CLARIFICATION#5

LOT 1: LAPSIPHEDI-RATMATE-NEW HETAUDA 400kV D/C TRANSMISSION LINE

Ref No: MCA-N/ETP/CB/003

Date: 16 March 2023

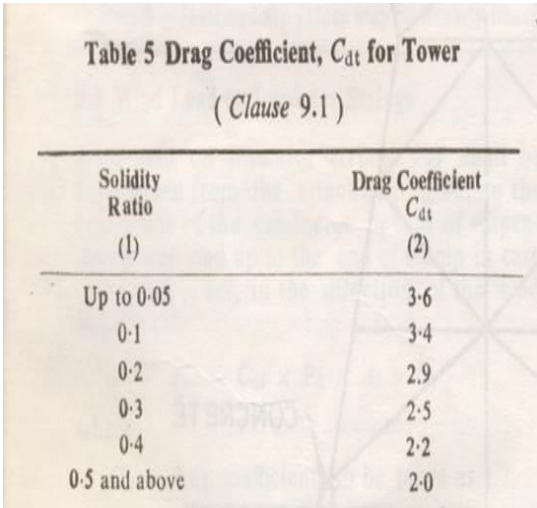
So, we request you to share the latest updated complete document on this.	
252.	<p>2. <u>Insulator</u></p> <p>a. As per Annex D, Appendix 8 – Insulator Specification – Rev. 1 page 2.6</p> <p>The combined M&E strength (M&E) and proof routine test load are loads specified by the Supplier that must be verified during an electrical-mechanical load test.</p> <p>Our Query</p> <p>According to IEC 60383 Table 3 cross reference list of tests for String Insulator Units -- M&E Test is applicable only on Porcelain (Ceramic Disc) and not on Toughened Glass Disc Insulators</p> <p>Kindly confirm</p> <p>b. As per Annex D, Appendix 8 – Insulator Specification, Cl. 3.2. Routine Tests:</p> <p>Hot to Cold Thermal Shock Test – All insulators shall be subjected to Hot to Cold thermal shock test in accordance with clause 24 of IEC 60383-1</p> <p>Our Query</p> <p>According to IEC 60383 Table 3 cross reference list of tests for String Insulator Units – Thermal Shock Test is a sample test on Toughened Glass Disc Insulators. It is not possible to conduct it on 100% of units.</p>	<p>Confirmed, use either IEC or ANSI standards.</p> <p>Confirmed, However, it should be ensured that proper Test Certification should be provided by the Manufacturers.</p>

<p>100% of Glass Shells are tested for thermal shock tests – which is conducted by glass shell-manufacturers.</p> <p>Kindly confirm the acceptance.</p> <p>c. As per Annex D, Appendix 8 – Insulator Specification, Cl. 3.2. Routine Tests:</p> <p>Flashover Voltage Test – All glass insulators shall be subjected to a flashover voltage test in accordance with clause 13 in IEC 60383-1.</p> <p>Our Query</p> <p>As per IEC 60383-1, clause 13 is a type test and not sample or routine test. It is not possible to conduct it on 100% of units, as it would not be feasible.</p> <p>d. As per Annex D, Appendix 8 – Insulator Specification – Rev. 1 page 2.7</p> <p>Clause-2.2, E 3.5 – “Only hot cured alumina type cement shall be used in insulator assembly. Sulpho aluminate or Portland cement is not allowed.”</p> <p>However, as per Clause - 3.16. (Cement Expansion Test) in page 3.14 – “The cement expansion test shall be carried out according to clause 8.2.10 of ANSI C29.2B (only for Portland type cement).”</p> <p>The above mentioned clause (3.16) provides clear provision of the cement expansion test which shall be carried out according to clause 8.2.10 of ANSI C29.2B.</p>	<p>The test mentioned as per clause 13 in IEC 60383-1 is a dry lightning _withstand voltage test and not a flashover test.</p> <p>Alumina type cement.</p>
